Kyleakin Pier – Request for clarification of issues relating to Chapter 18 of EIS.

Response to comments made by SNH email 28th December 2016 as applied to the Addendum (March 6th) to the report

Figure C3.1A: Location and extent of the proposed dredge area in relation to -9.5m CD contour.

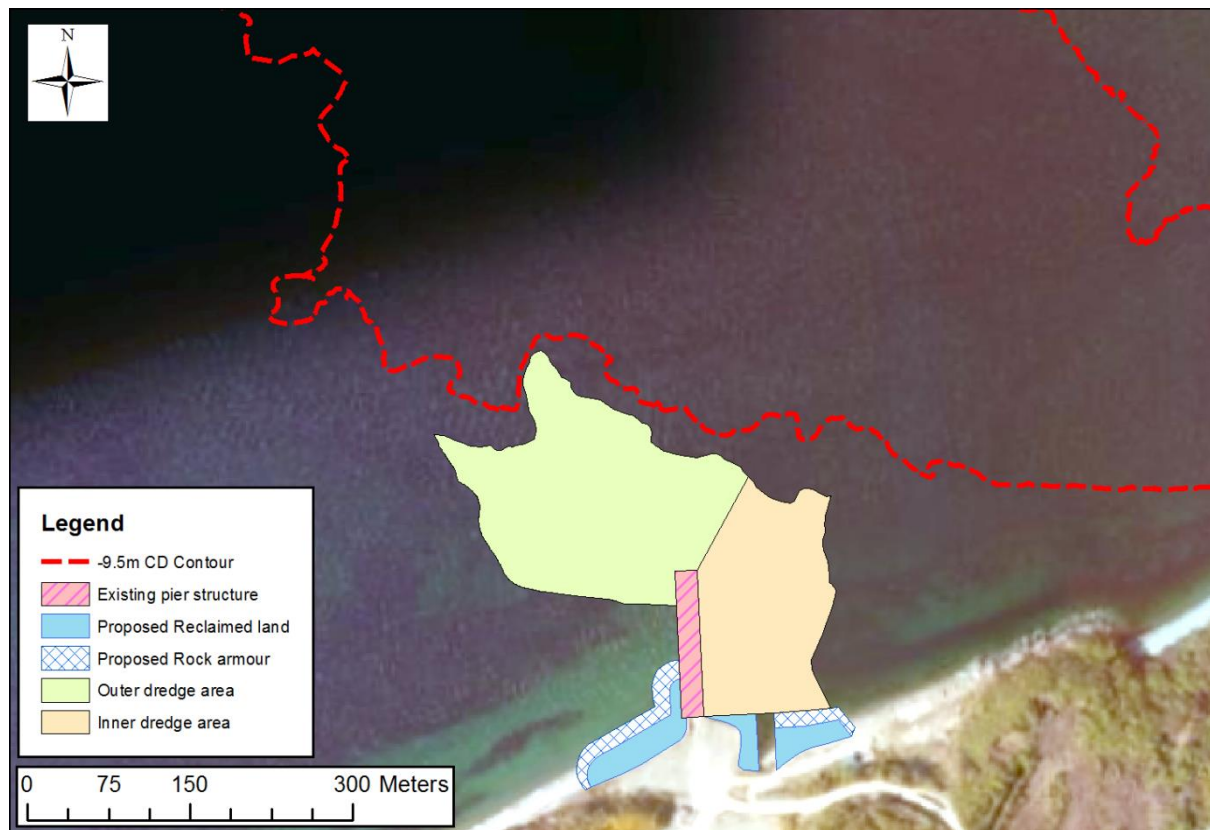
Comment 3

The inner and outer dredging areas are illustrated in Figures 8.2, 8.3 and 8.4 of RPS' Hydraulic Modelling Report. For convenience, these areas have been illustrated again in Figure C3.1A below. The inner and outer dredge areas were chosen to reflect the heterogeneous nature of the sediments comprising the seabed in these areas and the possible dredging methods that could be used to dredge each respective area.

The dredging simulations have been undertaken for the dredging of both areas using a Backhoe Dredger as per the tenderers proposals. Thus no part of the dredging has been omitted from the simulations. Figure AD5 in the Addendum Document presents examples of the typical dredging plumes at various stages of the tidal cycle to give the reader an idea of how the plumes move about under the influence of the tide. The plume for the “inner” area was selected as the bed sediment in the “inner” area include finer material than in the “outer” area making the plumes from the inner area more visible than those during the dredging of the outer area.
